**TOWN OF NEWBURGH
PLANNING BOARD
TECHNICAL REVIEW COMMENTS**

PROJECT NAME: FANA DEVELOPMENT LLC
PROJECT NO.: 25-21
PROJECT LOCATION: SARVIS LANE - SECTION 17, BLOCK 1, LOT 19
REVIEW DATE: 31 OCTOBER 2025
MEETING DATE: 6 NOVEMBER 2025
PROJECT REPRESENTATIVE: ACES SURVEYING, JONATHAN N. MILLEN, LLS

Sheet
1
 of 3

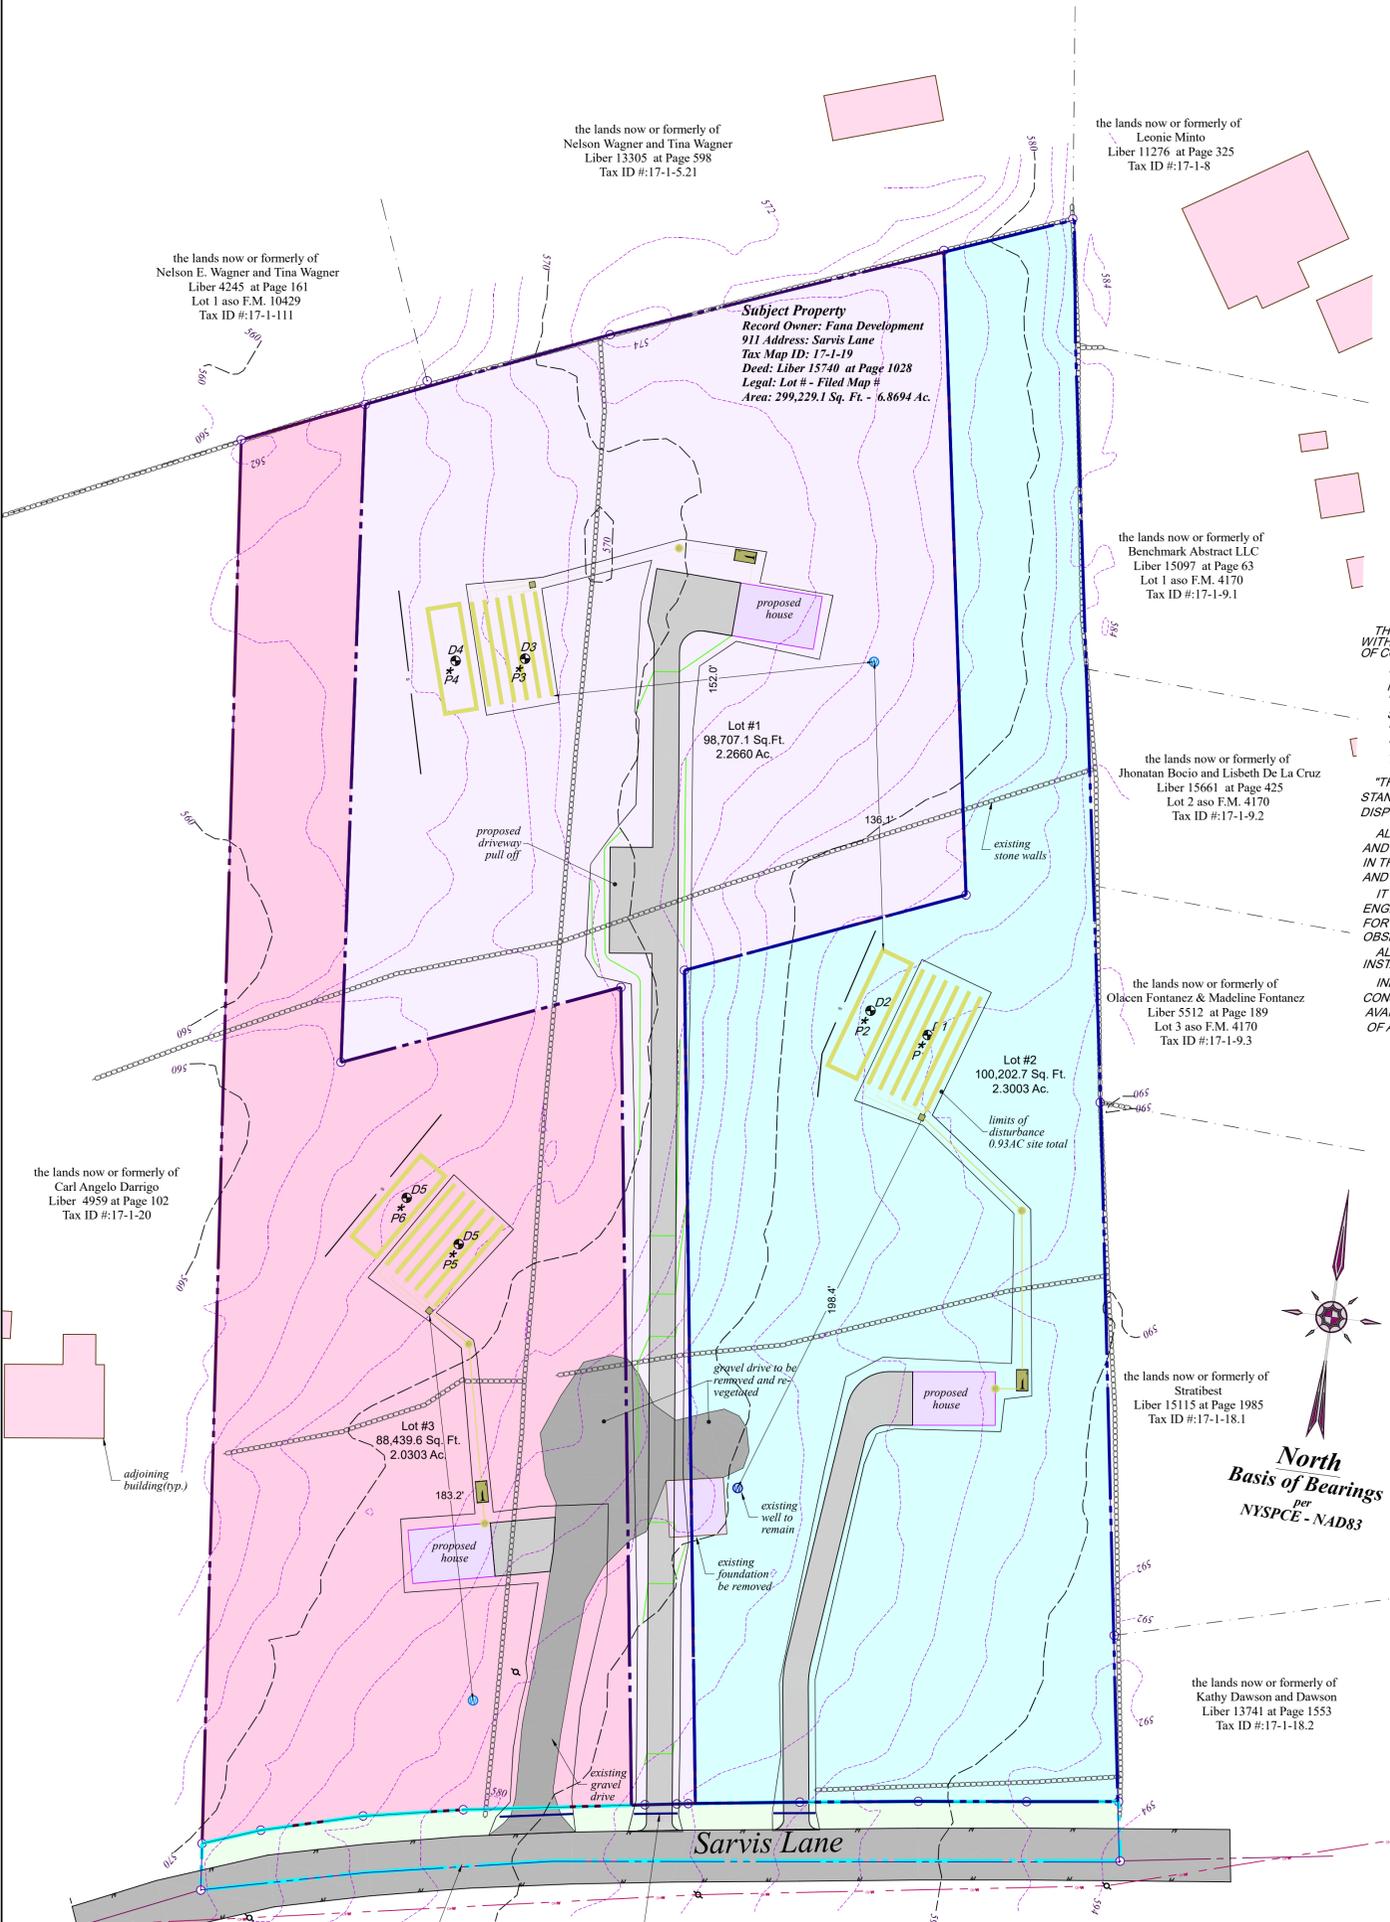
1. The access strip has been widened to a 25-foot strip for the flag lot.
2. The Highway Superintendent has reviewed the plans. Highway Superintendent questioned the driveway for proposed Lot 3 being 30 feet wide. This is an existing condition while the other two driveways meet the residential driveway requirements.

3. The applicant's representative have identified the limits of disturbance on the site at 0.93 acres total. Any disturbances in excess of 1 acre on the site will require coverage under the NYSDEC Stormwater SPDES Permit System. Notes should be added to the plans requiring stake out of the limits of disturbance as depicted on the plans in order to ensure less than 1 acre disturbance occurs. Areas of disturbance should be demarcated with orange construction fencing prior to issuance of a building permit for any of the lots.
